S/D No.: 86-17 Name: NOORDHOEK ADDITION

Re: S/D 86-17 - Final Plat of Noordhoek Addition.

FINAL PLAT

NOORDHOEK ADDITION

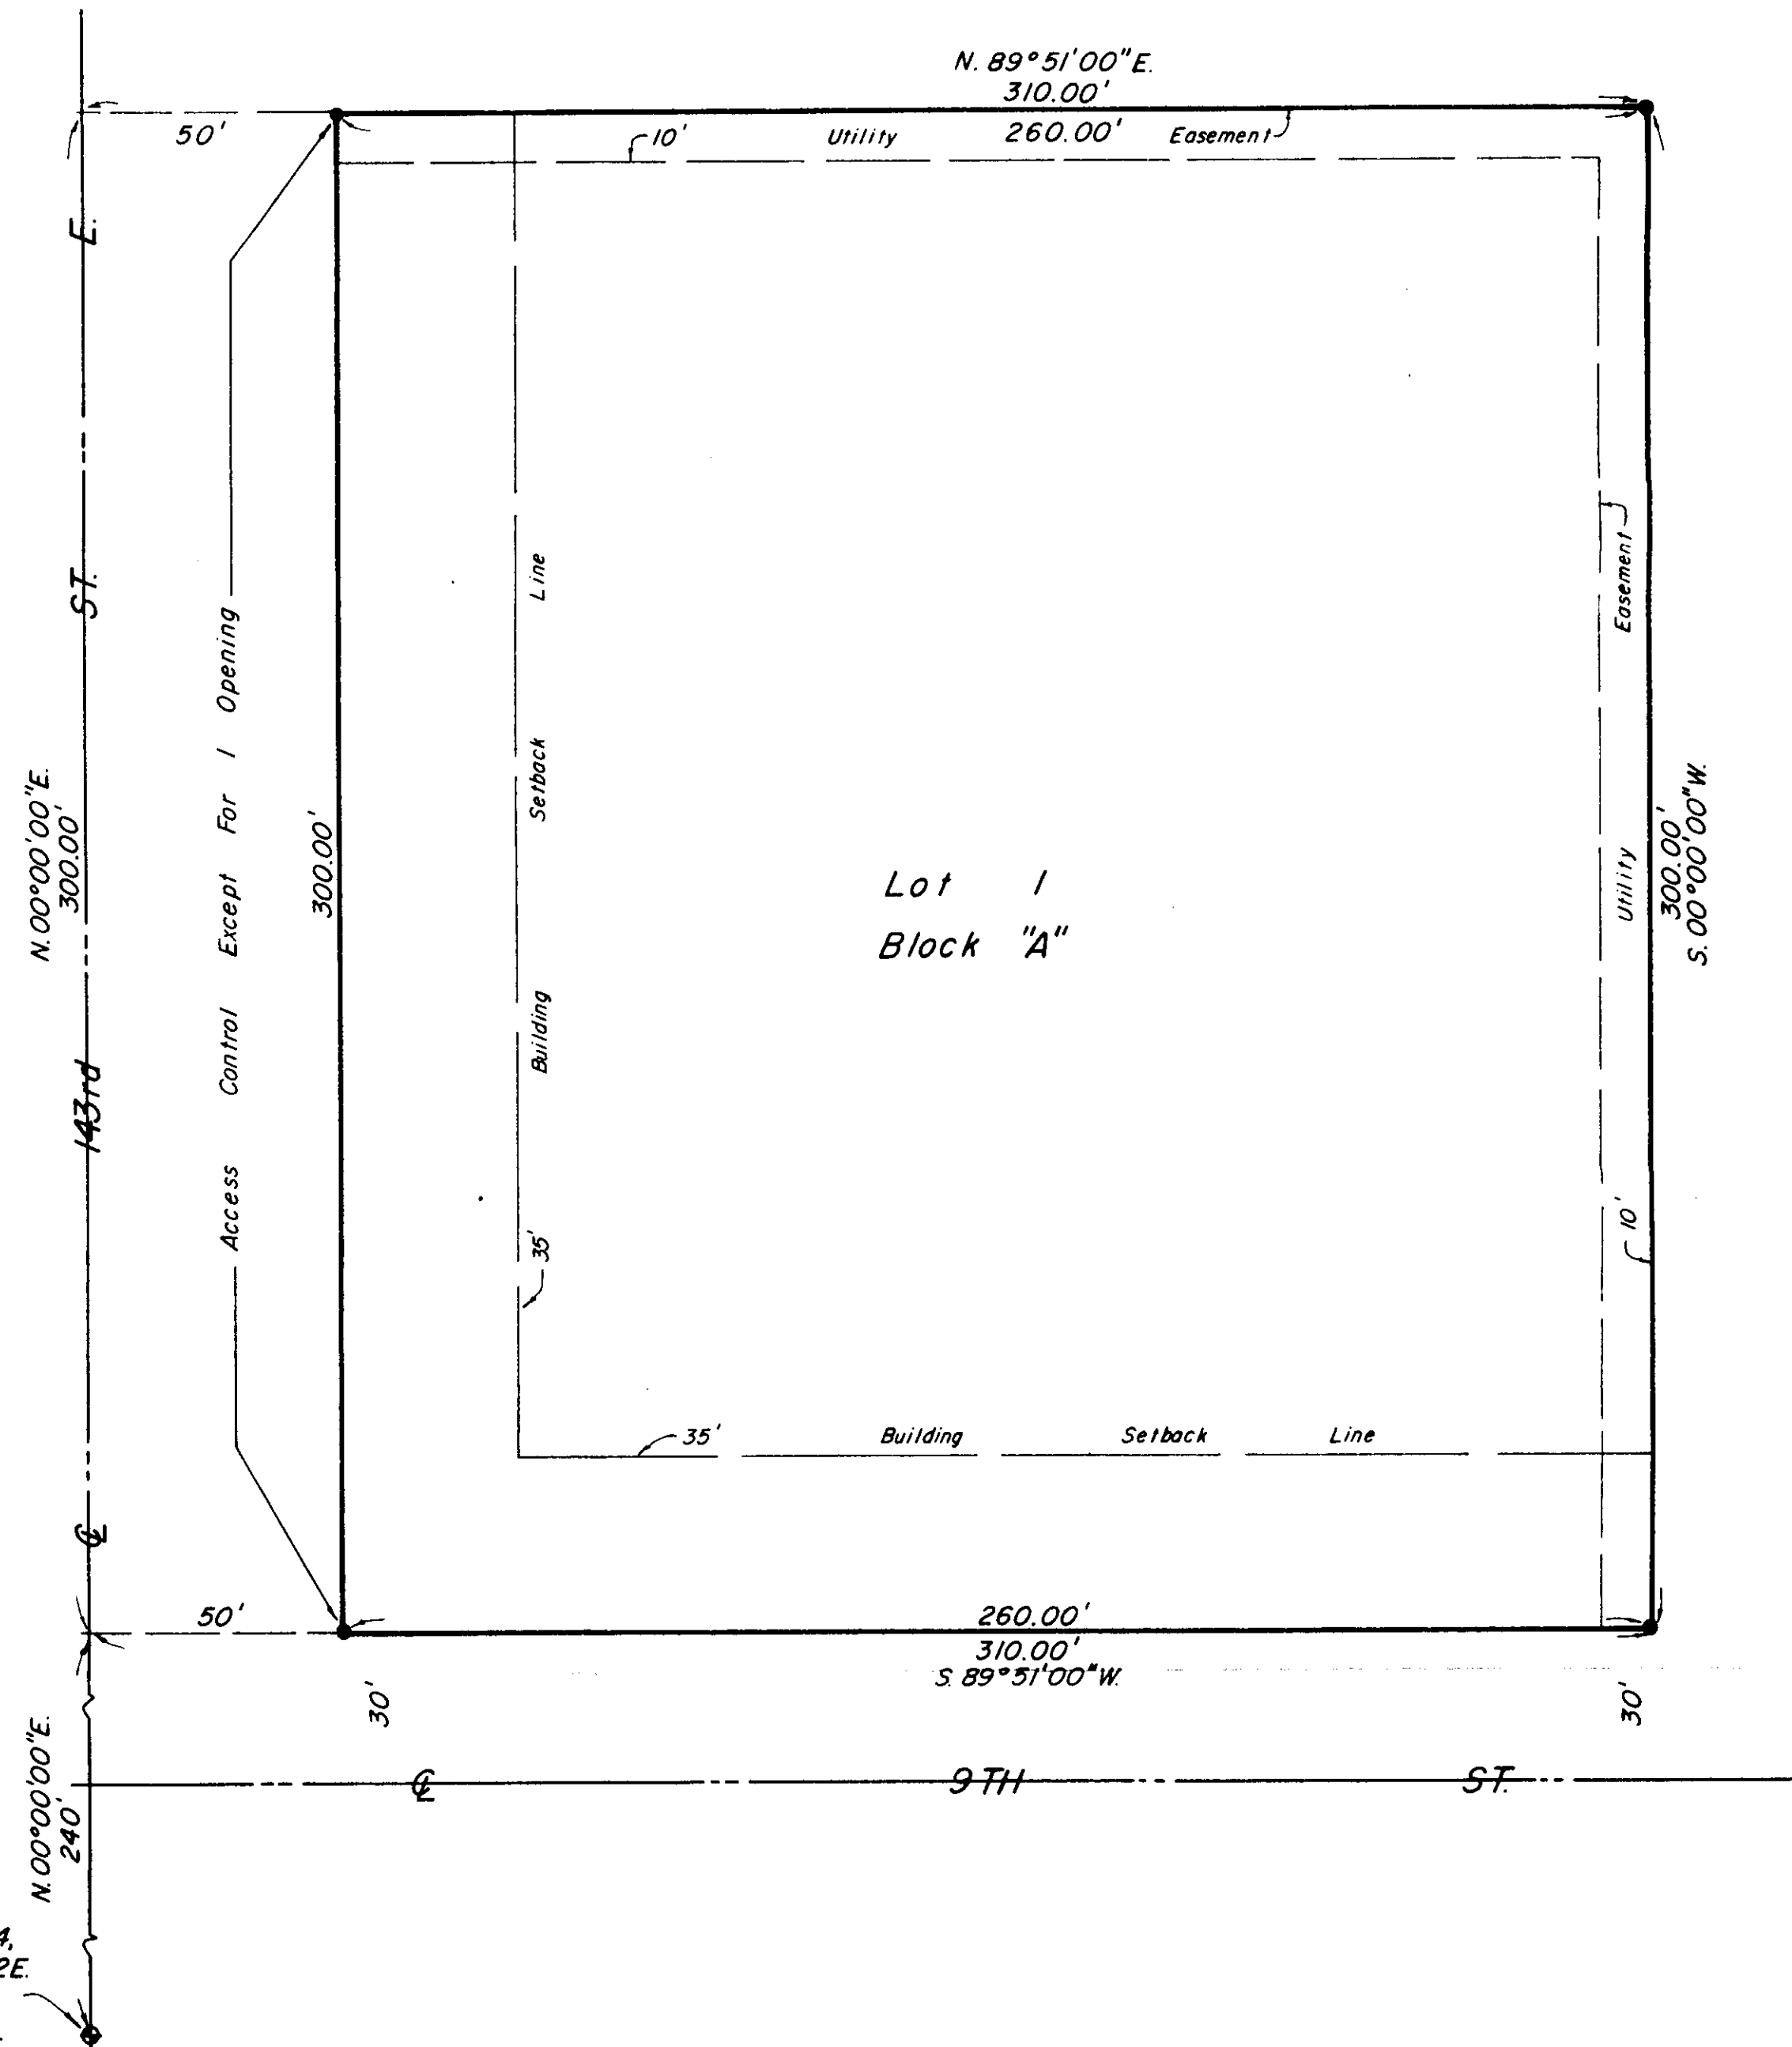
Need City oppr block

Notary Block
